DOCUMENTATION TRANSMITTAL

Documentation Description: Nonconformance Report - A-00081

NONCONFORMANCE REPORT

16 NCR NO. A-00081  
 17 DATE ISSUED 10-11-83 18 REV 0  
 19 PAGE 1 OF 5

LOOKING EAST @ WEST FACE @ 5.3 LINE WALL

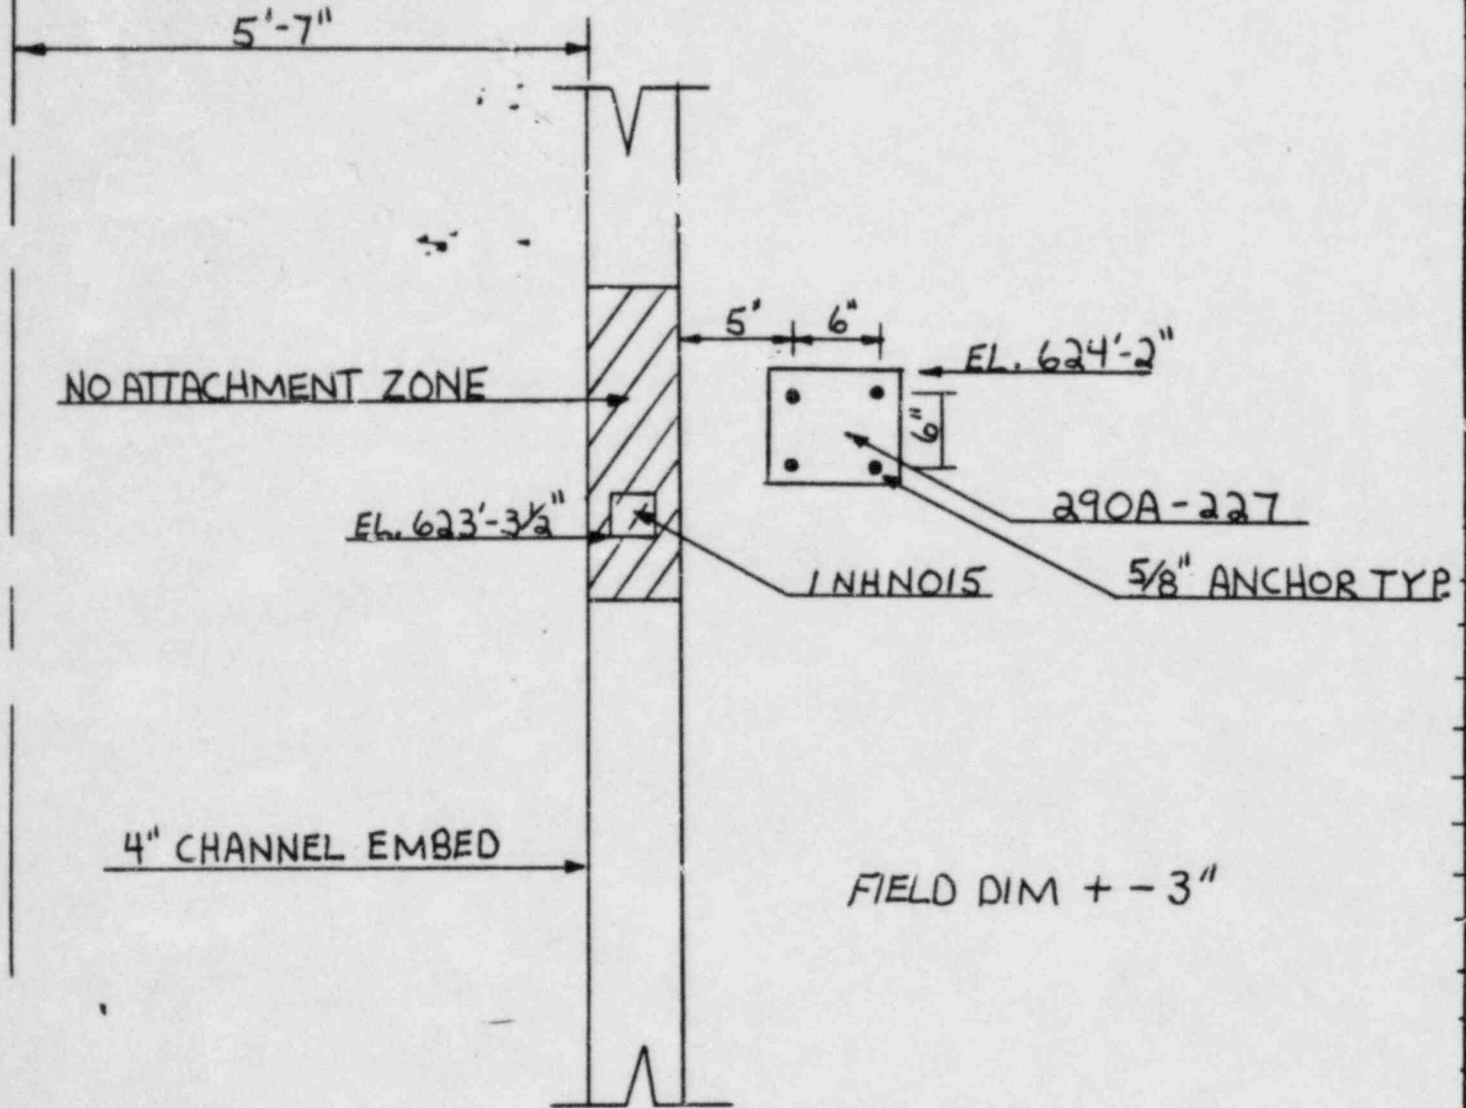
13 NONCONFORMANCE  
Contrary to the above, various items are within the proximity of R=6" +E to Channel Embeds with attached loads. See pages 2 THRU 5
